Application for Horizon Oil Sands Processing Plant and Mine Tailings Management Plan

Alberta Energy Regulator

Decision 20171218A: Canadian Natural Resources Limited; Application for Horizon Oil Sands Processing Plant and Mine Tailings Management Plan

Figure 1. Profile for legacy fluid tailings

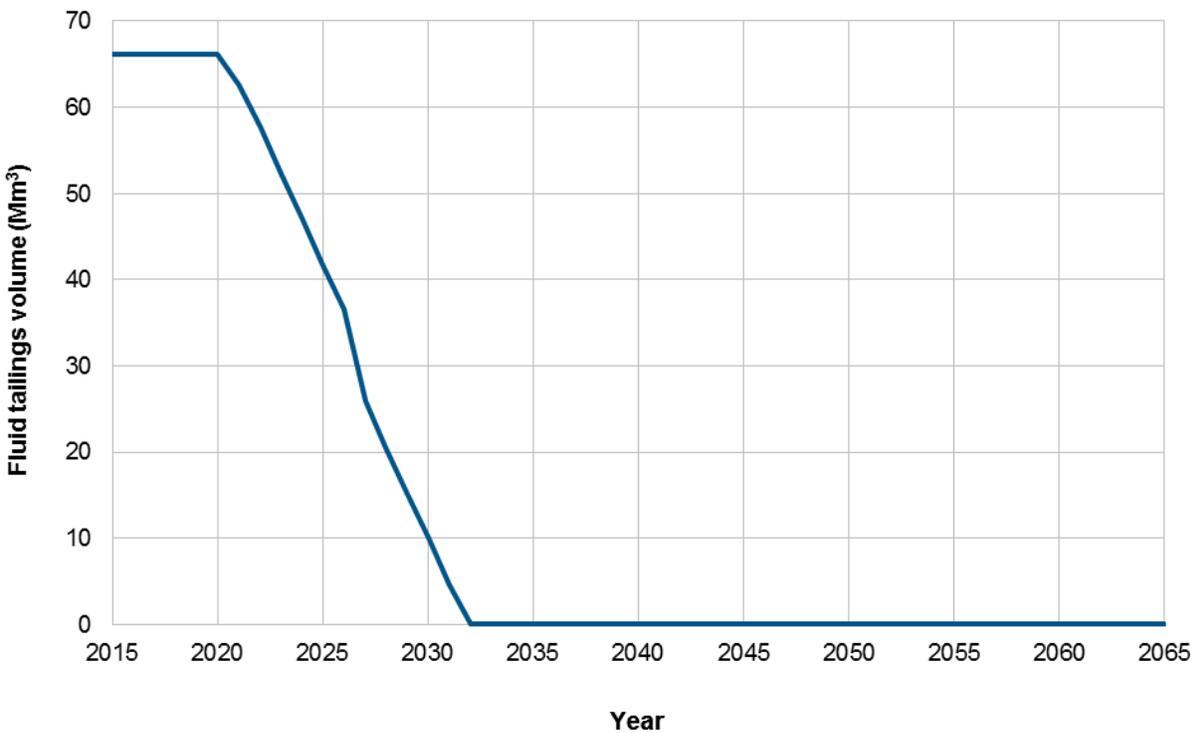
[34] Canadian Natural is required to achieve the profile for legacy (equivalent) fluid tailings as shown in figure 1. Canadian Natural’s legacy fluid tailings must achieve RTR status by 2032.

[36] Canadian Natural’s profile for legacy (equivalent) fluid tailings meets the *TMF*’s objective as a volume equivalent to 66.2 Mm³ in ETF/DDA1 would be treated and would achieve RTR status by 2032, 23 years before end of mine life.

[37] Although Canadian Natural is not allocating the volume of fluid tailings in ETF/DDA1 meeting ready-to-reclaim (RTR) criteria to its legacy (equivalent) fluid tailings volume inventory until 2020, the AER finds this reasonable as Canadian Natural is still ramping-up its nonsegregating tailings (NST) technology, including MFT-spiked NST, and the profile for legacy (equivalent) fluid tailings is still achieving the *TMF*'s objective.

[38] Canadian Natural's profile for legacy (equivalent) fluid tailings may or may not be affected by resulting uncertainty in the performance of NST and MFT-spiked NST technology and deposits that will be understood during the ramp-up period for the technology implementation. *Directive 085* identifies the situations (e.g., increased risk of not meeting milestones) where the AER will consider a regulatory response (e.g., requiring implementation of an alternative solution), and when amendment applications are required.

Figure 2. Profile for new fluid tailings

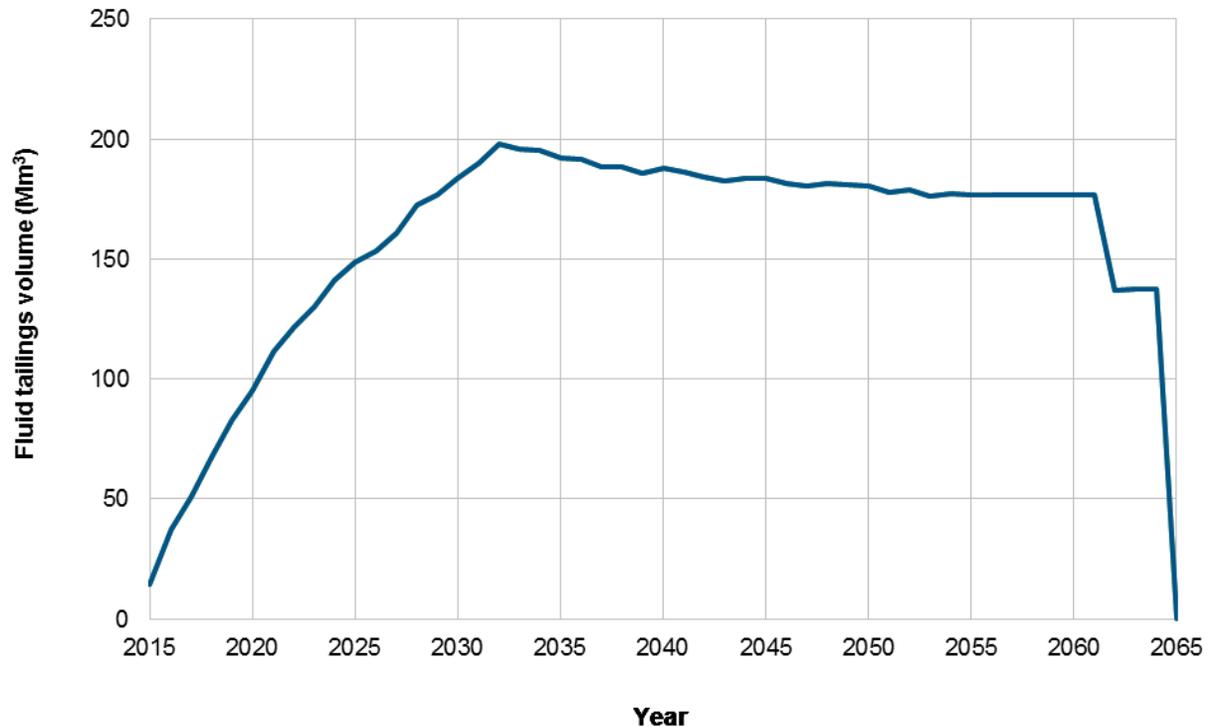
[41] Canadian Natural's profile for new fluid tailings meets the *TMF*'s objective and is approved subject to the approval conditions. The approval conditions require Canadian Natural to provide a revised end of mine life target which is no greater than 5 years of fluid tailings production by September 30, 2025.

[42] Canadian Natural is required to achieve the profile for new fluid tailings as shown in figure 2.

[46] The SOC filers, including FMFN, raised concerns with Canadian Natural's proposition that, because it was contemplated in the 2013 TMP, the end of mine life target is 177 Mm³. Canadian Natural is required to provide a revised end of mine life target which is no greater than 5 years of fluid tailings production by September 30, 2025. This revision may or may not result in an updated profile for new fluid tailings and an amendment application under *Directive 085*.

[47] The AER also finds that there are uncertainties in Canadian Natural's assumptions that could affect Canadian Natural's profile for new fluid tailings. Canadian Natural's mine plan is based on approval of the MFTRMP for the life of the mine, and the MFTRMP is only authorized until September 30, 2022 (see *Fluid Tailings Treatment Technology* section).
